**ZONING AMENDMENT &
PLANNED UNIT DEVELOPMENT
STAFF REPORT**

Date: June 17, 2010

<u>NAME</u>	Don Williams
<u>DEVELOPMENT NAME</u>	Rich's Car Wash
<u>LOCATION</u>	1066 Hillcrest Road (Northwest corner of Hillcrest Road and Johnston Lane)
<u>CITY COUNCIL DISTRICT</u>	District 6
<u>PRESENT ZONING</u>	R-1, Single-Family Residential and B-2, Buffer Business District
<u>PROPOSED ZONING</u>	B-2, Buffer Business District
<u>REASON FOR REZONING</u>	Rezoning from R-1, Single-Family Residential District and B-2, Buffer Business District to B-2, Buffer Business District eliminate split zoning for an existing car wash.
<u>AREA OF PROPERTY</u>	1 Lot / 1.9 ± Acres
<u>CONTEMPLATED USE</u>	<p>Planned Unit Development to allow a car drying/vacuuming shed, oil change building, office and customer waiting area on a single building site, and Rezoning from R-1, Single-Family Residential District and B-2, Buffer Business District to B-2, Buffer Business District eliminate split zoning for an existing car wash.</p> <p>It should be noted, however, that any use permitted in the proposed district would be allowed at this location if the zoning is changed. Furthermore, the Planning Commission may consider z

SITE PLAN

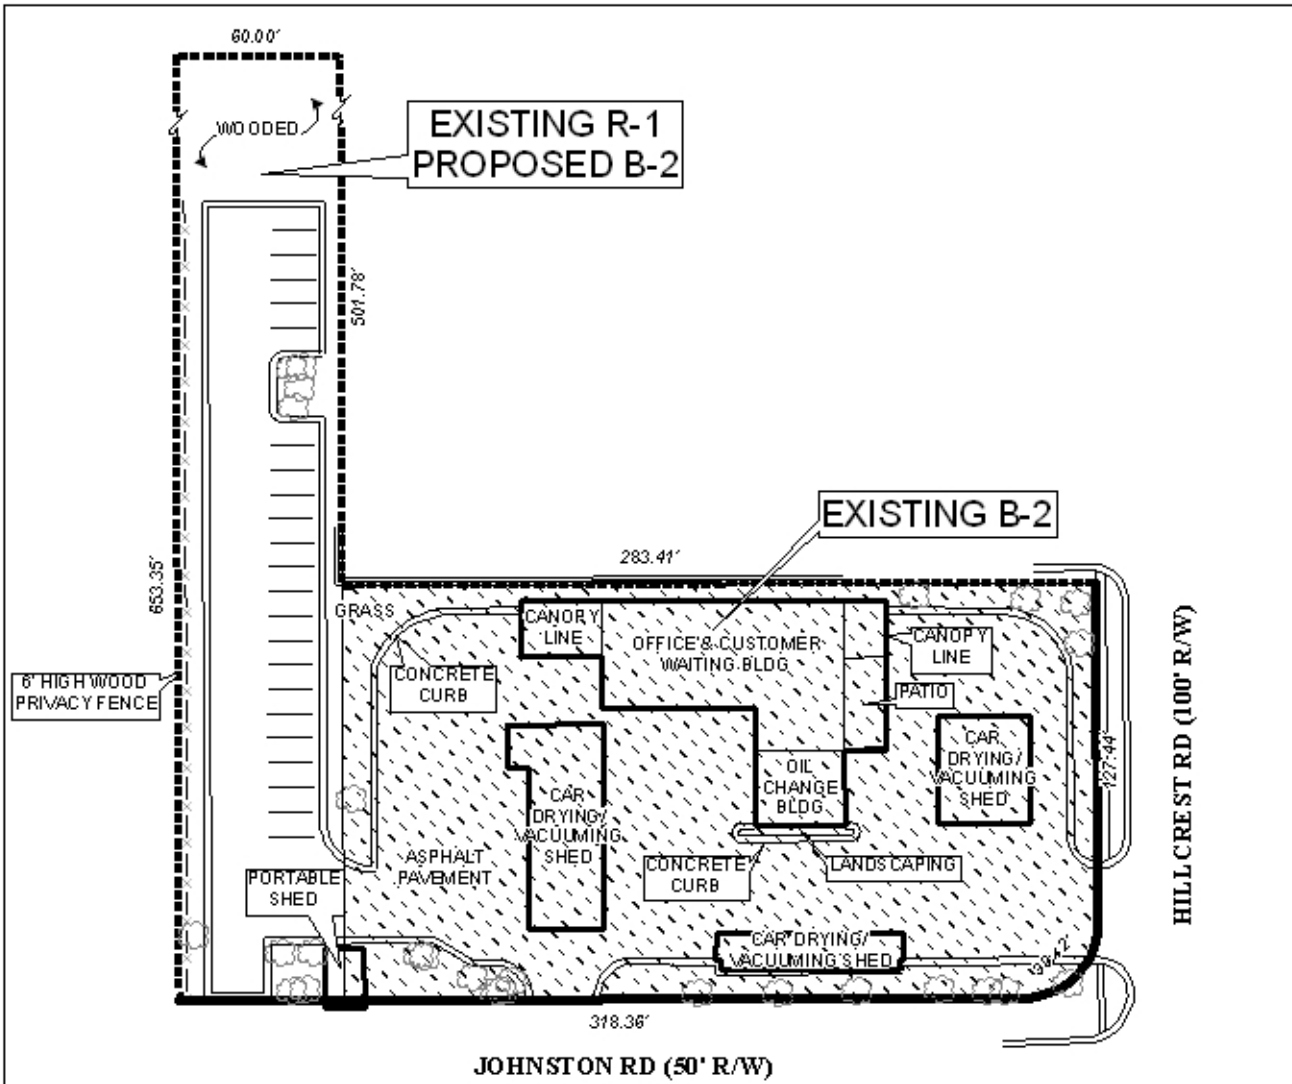
It should be pointed out that the applicant has applied for a variance due to the fact that one of the car drying/vacuumping sheds sits 11' closer to Johnston Lane than the 20' minimum minor street frontage setback allows.

Full compliance with the tree and landscaping requirements of the Zoning Ordinance is typically required for properties going through the rezoning process. Full compliance for this site would require 16 overstory frontage trees, and 9,930 square feet total landscape area, of which 5,960 square feet to be provided as front landscape area. It should be noted that the site plan submitted illustrates full compliance with the tree and landscape requirements of the Zoning Ordinance.

Dumpster locations for the site are not depicted on the site plan to comply with Section 64-4.D.9 of the Zoning Ordinance; therefore, the applicant should make a provision for dumpster locations and place a note on the site plan stating that dumpsters will be completely screened from view. If dumpsters will not be used, provide a statement indicating such, and how garbage will be removed from the site. It should be noted that aerial photographs show that the site has a dumpster placed in the right-of-way of Johnston Lane.

Any new lighting on the site must comply with the requirements of Sections 64-4.A.2. and 64-6.A.3.c. of the Zoning Ordinance, and a note stating such should be placed on the revised PUD site plan, if approved.

- 1) provision of a 6' high wooden privacy fence along the entire Western portion of the site to comply with Section 64-4.D.1;
- 2) depiction of dumpster location on the site plans to comply with Section 64-4.D.9 of the Zoning Ordinance and placement of a note on the site plans stating that dumpsters will be completely screened from view or placement of a note stating how garbage will be removed and that drainage from any new dumpster pads must connect to the sanitary sewer system via a grease trap/oil separator;

- 3) placement of a note on the site plan stating that the runoff from the vehicle washing facility must drain to the sanitary sewer system, and the connection must include an oil separator;

- 4) placement of a note on the site plan stating that any new lighting on the site will comply with Sections 64-4.A.2. and 64-6.A.3.c. of the Zoning Ordinance; and

- 5) submittal of two copies of the revised PUD site plan to the Planning Section of Urban Development.
